NUCLEAR ENERGY INSTITUTE

Subject: Nuclear Energy Institute Comments on U.S. Nuclear Regulatory Commission Draft Regulatory Guide DG-1199, "Alternative Radiological Source Terms for Evaluating Design Basis Accidents at Nuclear Power Reactors" (*Federal Register* of October 14, 2009, 74 FR 52822).

DG-1199 Comments				
Item	Page	DG-1199 Section	Text	Comments and Recommendations
1		General Comment		<p>COMMENT</p> <p>The draft regulatory guide, DG-1199, has been issued for review and comment while other supporting documents are not yet publicly available, e.g., NUREG CR/XXXX and ANSI 5.4 (that form the technical basis for updates for the new proposed Non-LOCA gap release fractions), and other documents are either currently undergoing revision or will need to be revised as a result of the proposed changes in DG-1199, e.g., NUREG-1465, Regulatory Guide 1.89, and Standard Review Plan 15.01. This fragmented approach runs contrary to the agency's efforts to improve openness and transparency.</p> <p>RECOMMENDATION</p> <p>Proposed Revision 1 to Regulatory Guide 1.183 should not be finalized until all documents related to draft regulatory guide DG-1199 have been made available for concurrent

Figure 1

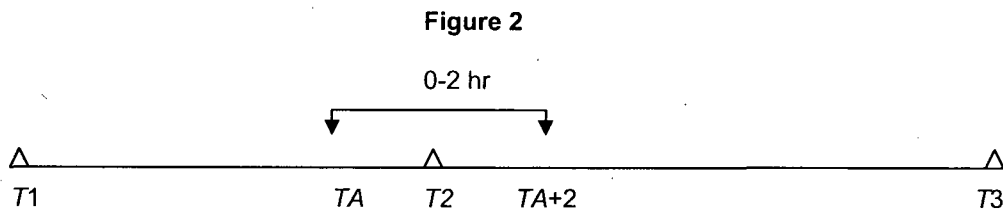
- 1) This note provides details for an alternative resolution of (Comment 76 – Will update comment reference in final version]. This note proposes a generalized set of guidelines for assigning the 0-2 hour control room χ/Q value to the 2 hour time span of the limiting release of radioactivity to the environment. The alternative resolution consists of replacing the last two sentences of the 2nd paragraph of § 5.3 with the following or equivalent:

"Recommendations are made for two cases. In the first case, the limiting 2 hour interval falls completely within an averaging period $T1-T2$ for the control room χ/Q as shown in Figure 1 below

$$(\chi/Q)_{((T1+2)-T2)} = \frac{(T2 - T1)(\chi/Q)_{(T1-T2)} + 2(\chi/Q)_{(0-2)}}{T2 - T1 - 2}$$

Here $(\chi/Q)_{((T1+2)-T2)}$ is control room χ/Q value over the averaging interval T1-T2. If (1) yields $(\chi/Q)_{((T1+2)-T2)} = 0$, then $(\chi/Q)_{((T1+2)-T2)}$ should be set to 0.
